Process Sheet

Customer : CU-DAR001 Dart Helicopters Services Drawing Name : BO 105 SKIDTUBE ASSEMBLY
 Job Number : 27722-1
 Estimate Number : 10112
 P.O. Number : N/A
 This Issue : 6/28/2006 S.O. No. : N/A
 Prsht Rev. : NC
 First Issue : N/A Type : LANDING GEAR
 Previous Run : 22369
 Part Number : D105674011G
 Drawing Number : D2966 REV A2
 Project Number : N/A
 Drawing Revision : A2
 Material : N/A
 Due Date : 7/5/2006 Qty: ② Um: Each
 Written By :
 Checked & Approved By : 06 06 29
 Comment : Est Rev: A 04.07.07 New Issue KJ/JLM

Drawing Name: BO 105 SKIDTUBE ASSEMBLY

From: David Shepherd [dshepherd@dartaero.com]
Sent: July 11, 2006 3:30 PM
To: 'Chris Provencal'
Subject: RE: NCR BO 105 Skidtube

D2966-1 DRILLING DETAIL

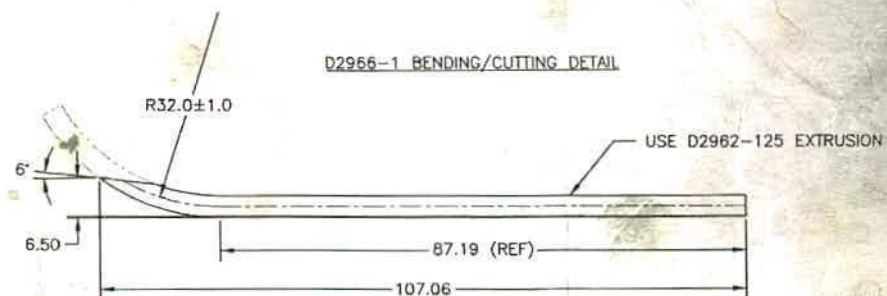
NCR: 27722-1		WORK ORDER NON-CONFORMANCE (NCR)						
DATE	STEP	Description of NC Section A	Corrective Action Section B			Verification Section C	Approval Design Mgr	Approval QC Inspector
			Initial Design Mgr	Action Description Design Mgr	Sign & Date			
06-07-21	3.0 6.0	Middle hole dims. are under tolerance. Hole spacing unacceptable. Tube scrap AS per attached e-mail.	CP 06.07.21 per QSI 042	destroy: replace tube verify sig dimensions. original qty was	CP 06-11-20	CP 06-11-20	CP 06.07.21 per QSI 042	CP 06-07-21

For the D2966-041 BO105 skidtube, two groups of holes are offset by 1/8". One group looks like ground handling, and is probably not too critical. Not sure what the fwd group is for. Is this acceptable?

There is a B105 skidtube that manufacturing has made an error. The dimension 67.13 shown on attached drawing is 67.062 now. I looked at the installation and I could not see what are those holes are for (maybe floats). Do you think if that is ok? Is it acceptable?

The fwd group of holes is for floats. Distance to aft group is critical and 0.100" is quite a bit out. Although it might work, I would be tempted to cut our losses and scrap this tube. We would probably spend more money trying to figure out if it would work or not.

You are correct. These holes are for the floats.
If they were at 0.188" size still, I would have suggested plugging and re-drilling.
However, given that they are almost full size, I recommend leaving as is.
You must respect the 1.250 dimension, but I think the 67.06 dimension is an acceptable deviation.
